Case No.: ADD2004-00060

Project Name: Coconut Point MPD

ADD2004-00060(C) & ADD2004-00187(A), 11JAN06, COCONUT POINT MPD, CORRECTIONS TO THE ADMINISTRATIVE APPROVALS TAKEN IN ADD2004-00060, ADD2004-00060A, ADD2004-00060B AND ADD2004-00187.

TYPICAL SECTION C-C
PRIVATE PROPERTY LAKE SETBACK

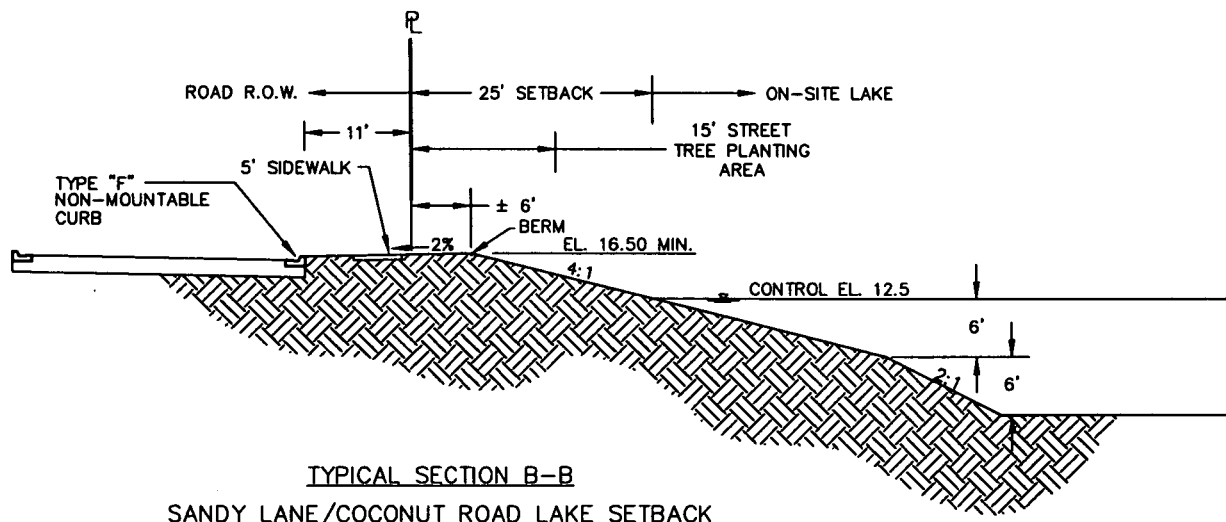
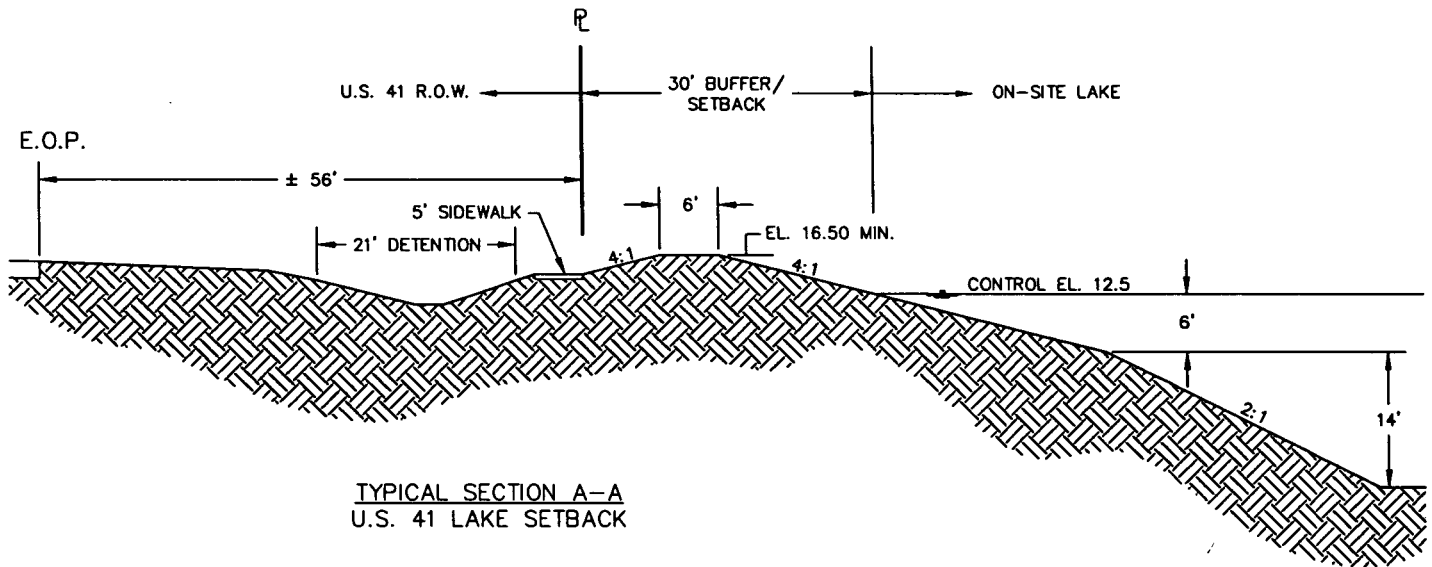
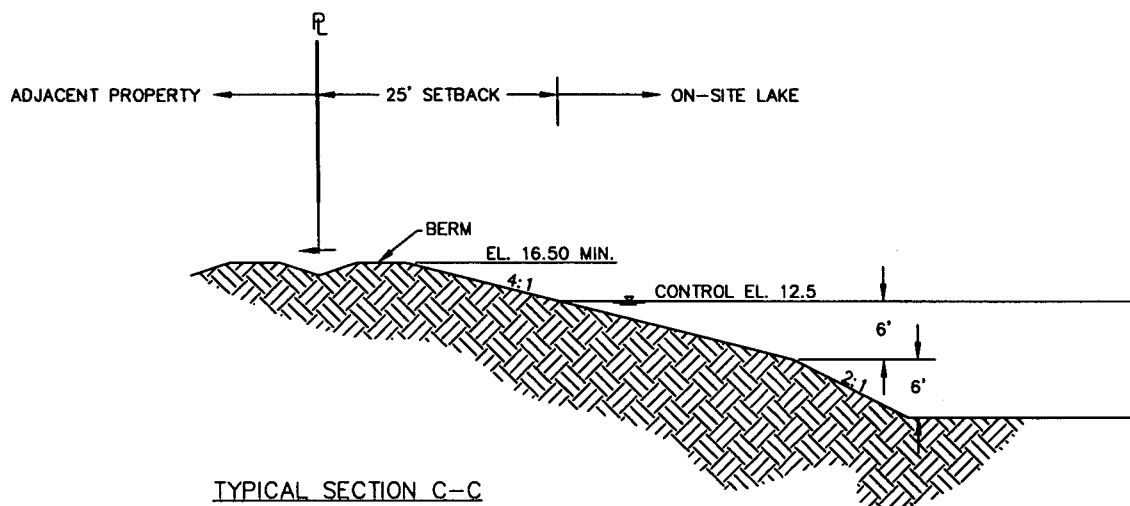
1. Adequate measures must be taken for wayward vehicles in accordance with LDC Section 10-329(d)(1) a.2., could include but is not limited to the use of a surface water management berm along Coconut Road, detention swale along located along US 41, a surface water management berm and 15 foot wide street planting area with type "F" non-mountable curb and gutter along Sandy Lane.
2. Development must be substantially consistent with the List of Deviations and Justifications, stamped received on JUN 30, 2004, and Figures No. EX 1 through EX 4, stamped received on JUN 30, 2004.

Justification for the deviation will be in the form of alternate provisions for protection of wayward vehicles as mentioned in the code section. At the U.S. 41 location, a surface water management berm 30 feet buffer/vegetation will be provided at the right of way line per Coconut Point Zoning Resolution #Z-02-009. In addition, a detention swale is located within the U.S. 41 right of way between the travel lanes and the eastern right of way line. At the Sandy Lane locations, a surface water management berm and 15' street tree planting area along with type "F" non-mountable curb and gutter will be utilized to provide protection of vehicles. At the private property line locations, a surface water management berm will be provided.

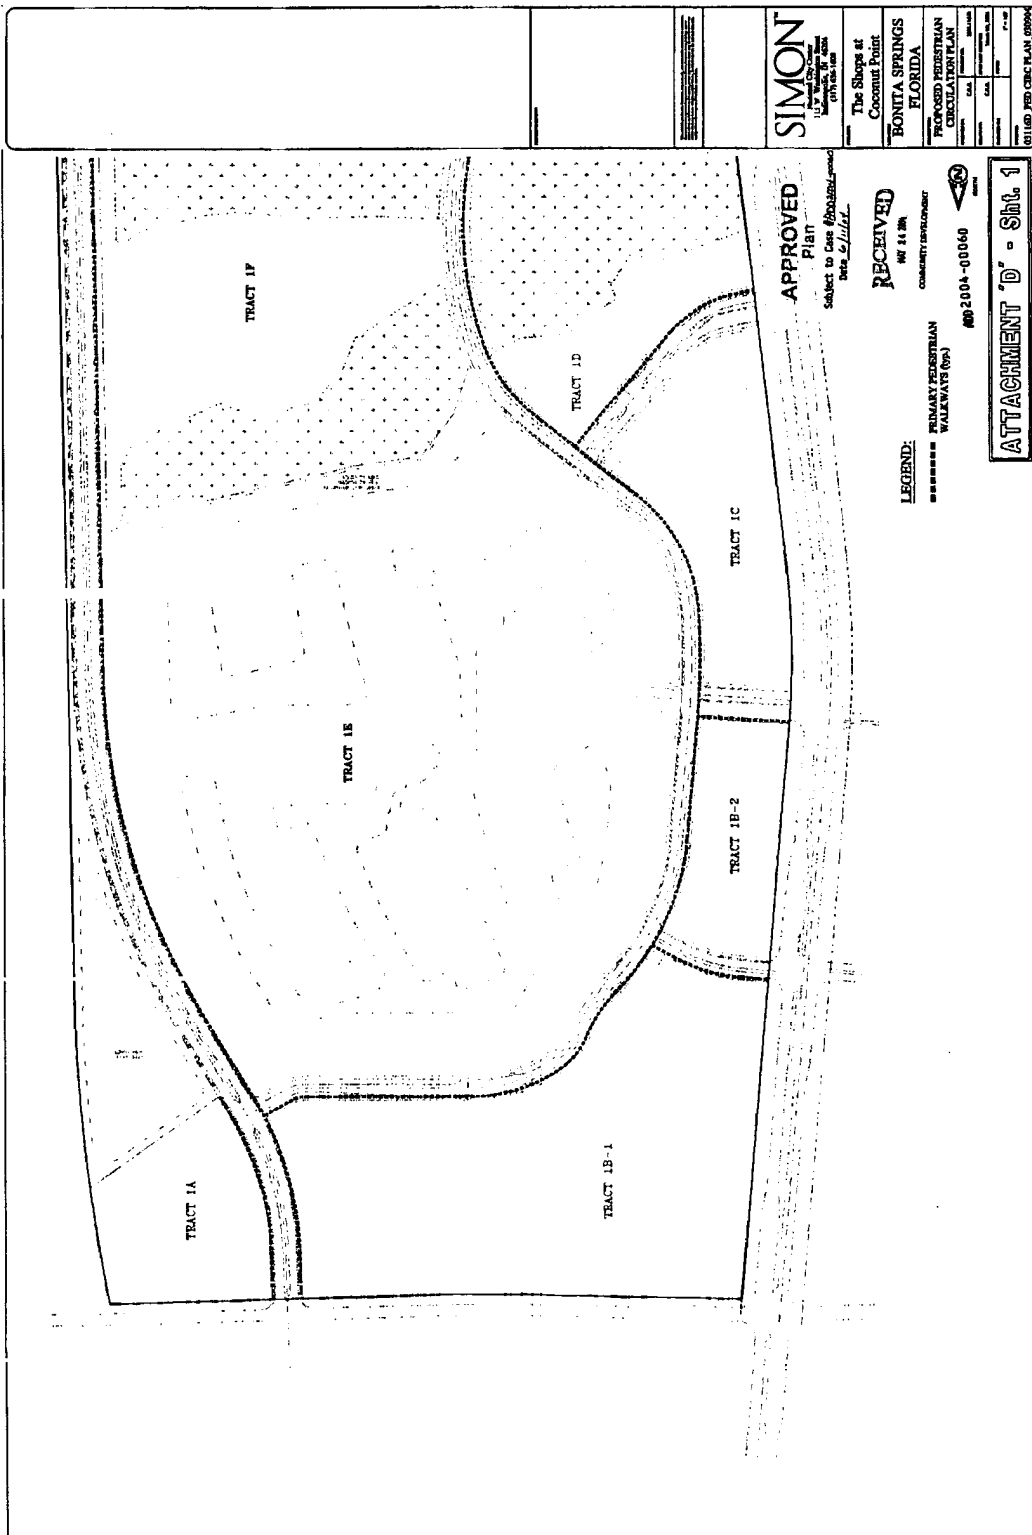
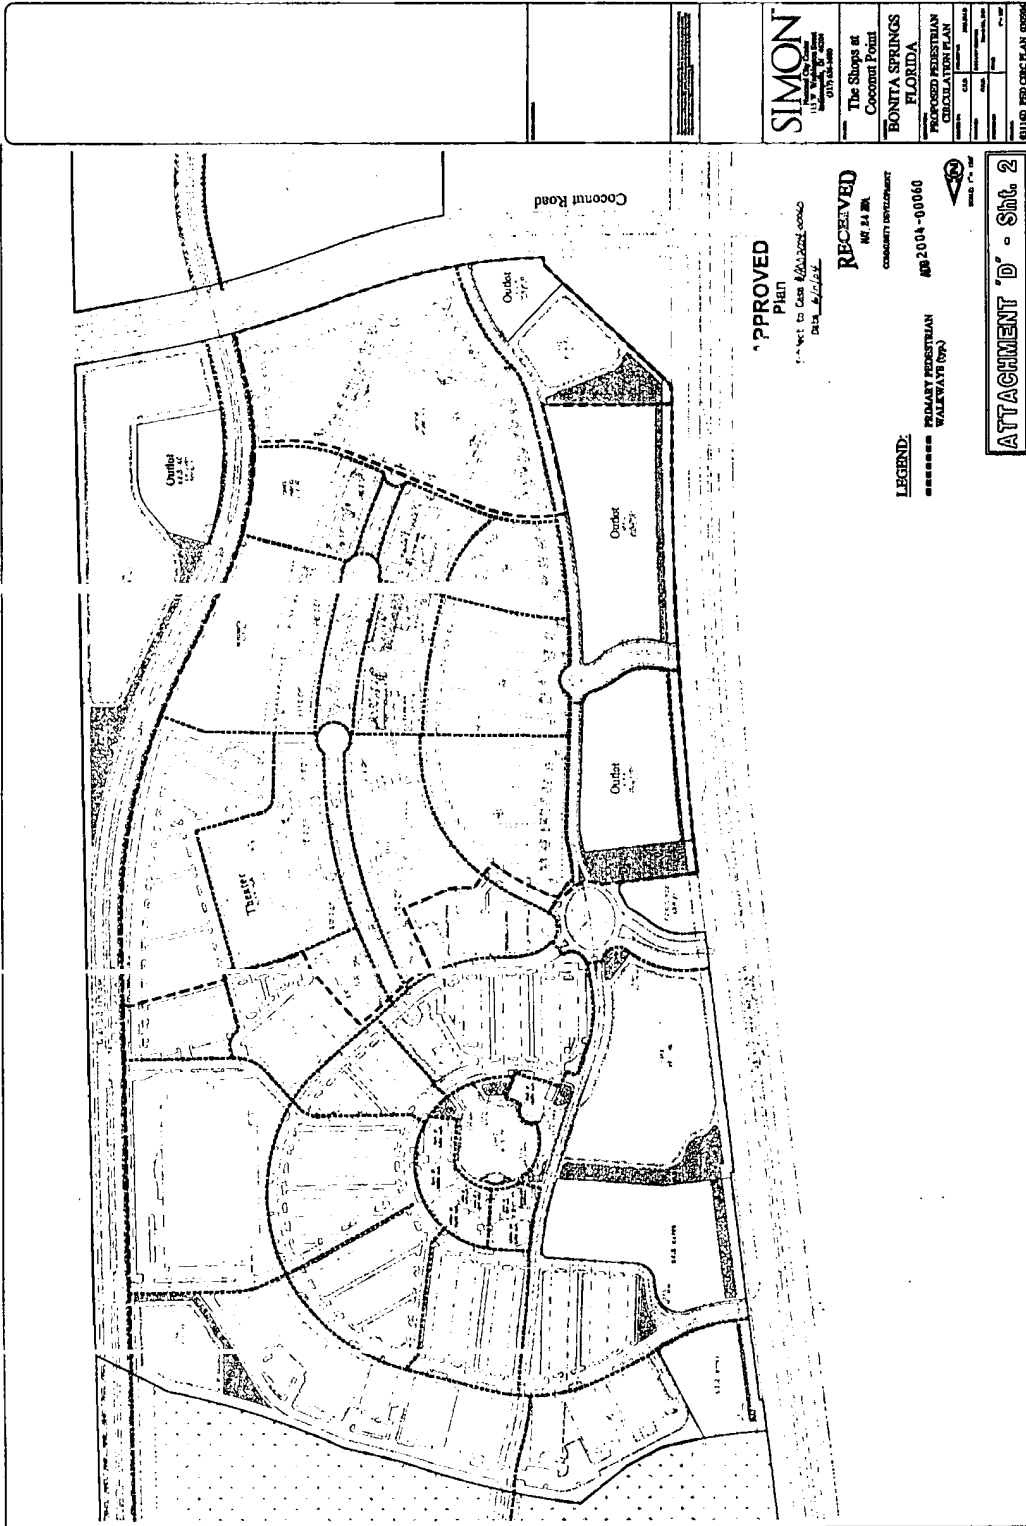
- 1. **Condition 1 of Resolution Z-02-009 is hereby amended to read as follows:**
 - 1. **The development of this project must be consistent with the one- page Master Concept Plan, stamped received May 24, 2004, except as modified by the conditions below. This development must comply with all requirements of the Lee County LDC at time of local Development Order Approval, except as may be granted by deviation as part of this planned development. If changes to the Master Concept Plan are subsequently pursued, appropriate approvals will be necessary.**

Bulkhead Planting Exhibit

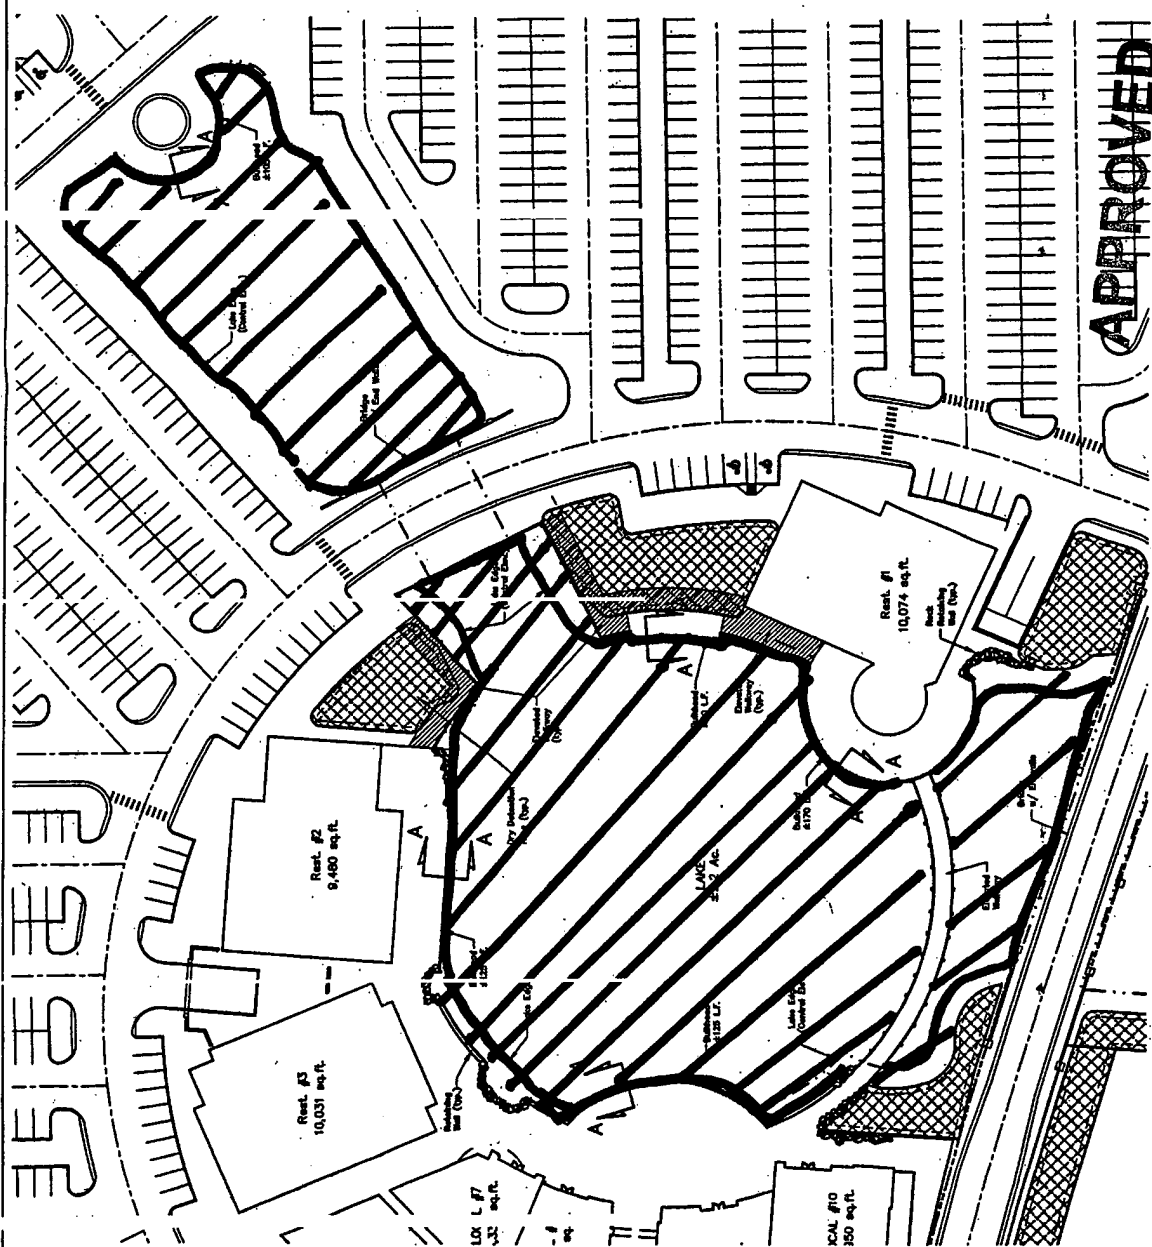
12. As a clarification of the original approval, if residential uses are proposed within buildings with commercial uses on the ground floor, the open space requirement is 30%.
13. Deviation seeking relief from LDC Section 10-329(d)(4) which requires slopes along the banks of excavation, to allow the use of bulkheads as delineated on the Plan noted as Attachment O, Bulkhead Exhibit. This deviation is APPROVED subject to the following condition:

If bulkheads are utilized in the final site design, then the Paving and Grading, and Landscape Plans must delineate the location of the bulkheads in substantial compliance with the attached Bulkhead Exhibit (attached hereto). The design of the lake adjacent to the bulkheads must include a compensatory littoral zone with a 4:1 slope with a 5-foot littoral shelf equivalent to the linear footage of the bulkhead along the bulkhead, or an alternative compensatory littoral zone reviewed and approved by the Division of Environmental Sciences. The littoral planting requirements within any lake utilizing bulkheads must be calculated as two (2) herbaceous littoral plants per linear foot of shoreline for the lakes delineated on the Bulkhead Planting Exhibit (attached hereto), and the placement of the littoral vegetation must be concentrated within the compensatory littoral zone. Native wetland trees and/or shrubs may be used to meet the littoral planting requirement with one 7-gallon tree or two 3-gallon shrubs credited as 10 herbaceous littoral plants.

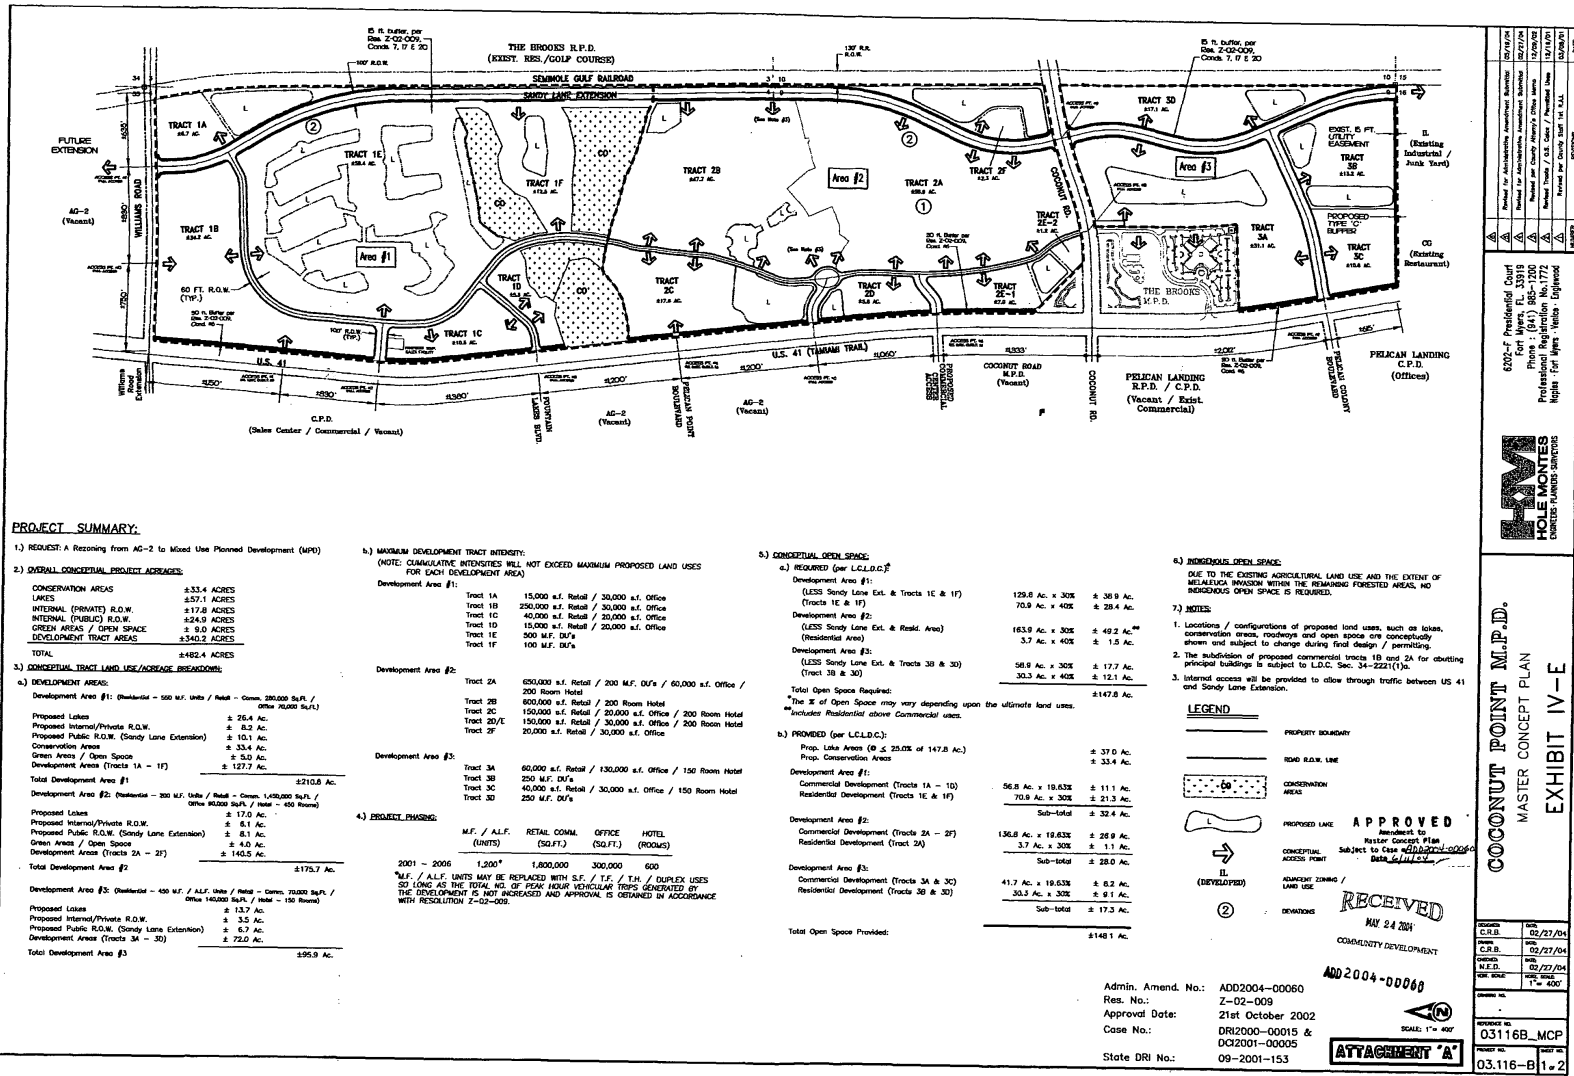
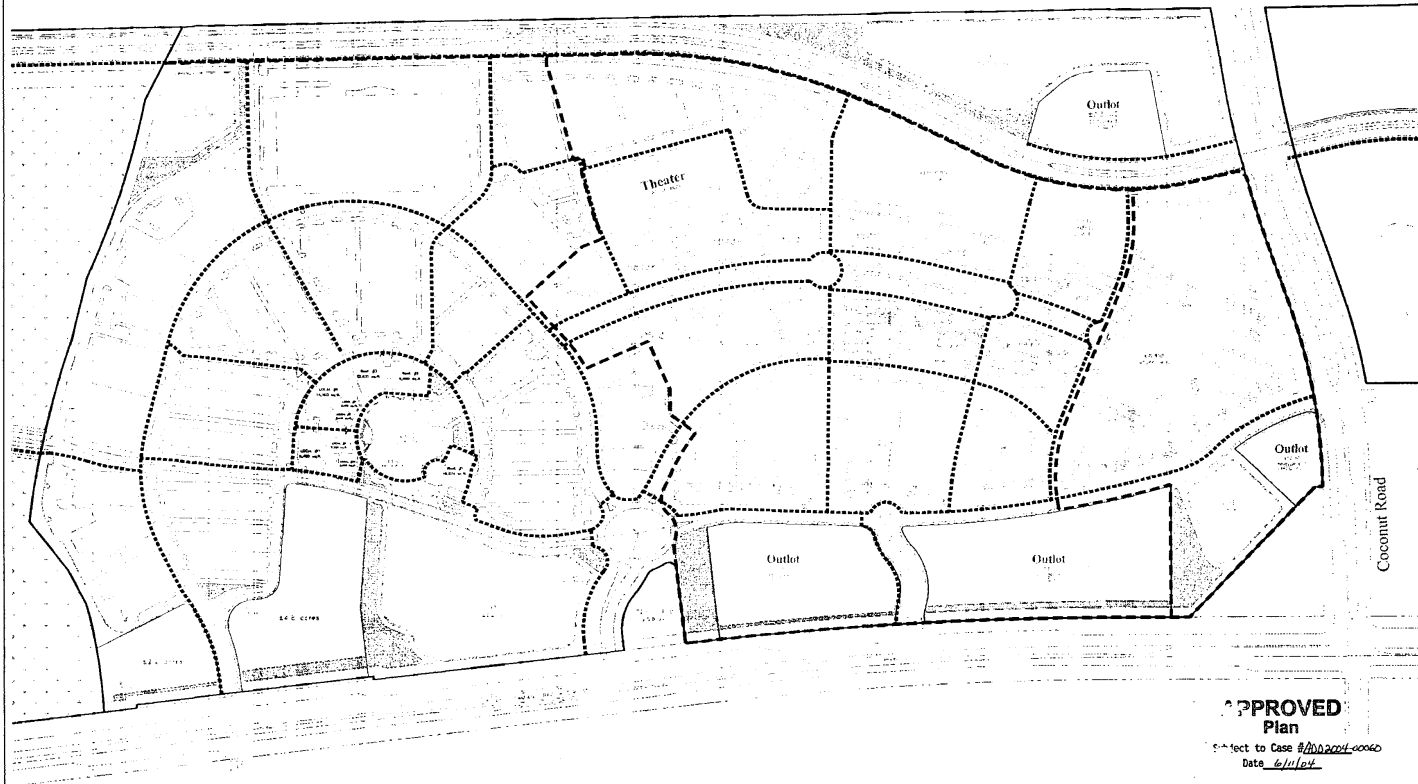
1. The only change approved to the approved Master Concept Plan is the arrangement of the lakes in Phase 1. Development must be in compliance with the originally approved Master Concept Plan attached to Resolution Z-02-009.

In Phase 1, the lakes may be developed in accordance with the amended Master Concept Plan for Coconut Point, stamped received APR 30, 2004. Master Concept Plan for ADD2004-00060 is hereby APPROVED and adopted. A reduced copy is attached hereto. The terms and conditions of the original zoning resolutions remain in full force and effect.
